**RE: Spring Gap-Stanislaus Hydroelectric Project; FERC Project No. 2130
Pinecrest Lake-level Study Plan**

**PINECREST RESERVOIR LAKE LEVEL STUDY PLAN
(INCLUDING CONSULTATION RECORD)**

**PINECREST RESERVOIR LAKE LEVEL STUDY PLAN
RESPONSE TO COMMENTS**

Figure 1. Pinecrest Reservoir Lake Level Study Recreational Facilities Included in the Analysis.

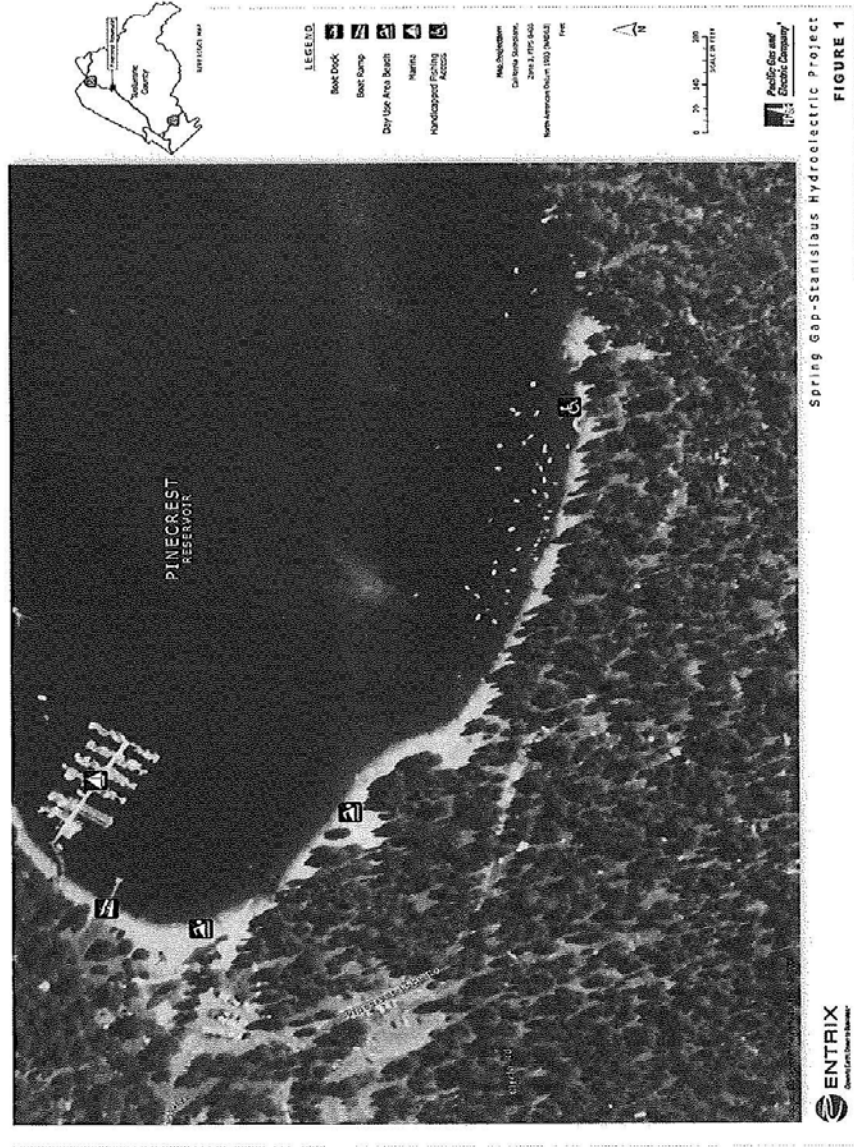
Figure 1 presents a map identifying the initial five (5) recreational facilities and uses under consideration in this study plan.

lowering the minimum reservoir water surface elevation below 5,617² feet in the range of 5,608 to 5,604 feet (ft) mean sea level (MSL). For each foot below 5,617 (ft), the plan will describe the effect on the selected recreational facilities and uses, if any, and will identify measures that will mitigate that effect, according to established criteria, to an acceptable level, if necessary. The plan will continue to reduce the examined elevation until elevation 5595 (ft) MSL, uses.

Figure 2. Example of Elevation Profile to be Measured at Boat Ramp.

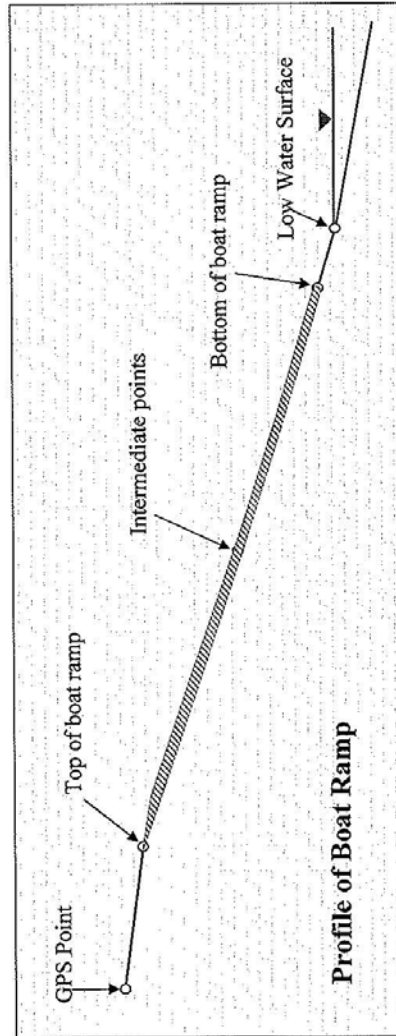
- Collect data at the five selected recreational facilities and locations (Figure 2). The digital terrain model survey will be used to generate five (5) transect profiles perpendicular to the shoreline for agreed upon recreational features. Profiles will be developed, at minimum, for the Day Use Area beach (2 profiles), the marina, boat ramp, and the handicap fishing access. The agreed upon Relevant recreational facilities and uses/features will be identified and measured as illustrated in Figure 2.

The data collection and color aerial ortho-photogrammetry survey will be performed between the winter of 2009/10 and fall (October 2010, 2010). Fall and winter is a key time for this survey because the water surface elevation in the lake is low and will allow direct measurement of elevations, to the lowest elevation to be considered, 5,604 ft MSL. By conducting the survey when the lake is at a lower elevation,

~~The base map field crews can measure attributes along the transects that may affect recreational use that are otherwise submerged during the recreation season. Also, there is a relatively low risk of weather delays at this time, compared to be 40 foot scale, one foot Contour Interval Mapping later in the year. Each transect profile will be measured beginning above the maximum operational elevation of the reservoir. Each transect will be measured with an overall color aerial ortho-photo of the Pinecrest lake shore study area. The extent of Trimble[®] resources grade Global Positioning System (GPS) unit. Each transect will be profiled from the upslope endpoint down to the water's edge. GPS data will permit mapping will include the area just northeast the profile locations relative to the recreation areas of the boat dock/marina, to just east of the handicap fishing access. Prominent boulders and stumps in these recreational areas will be field located horizontally and vertically, reservoir using a geographic information system (GIS) will be developed to manage the field data that is collected. The 40 foot scale one foot Contour Mapping and color ortho photo. Each profile will include measurement of the water surface elevation, which will be used as a base map in the GIS. Transect and other data that is collected as part to link transect measurements to reservoir operations. Water surface elevations, as measured by PG&E, for the days and times of this study the survey will be incorporated used in the GIS to assist in analysis.~~
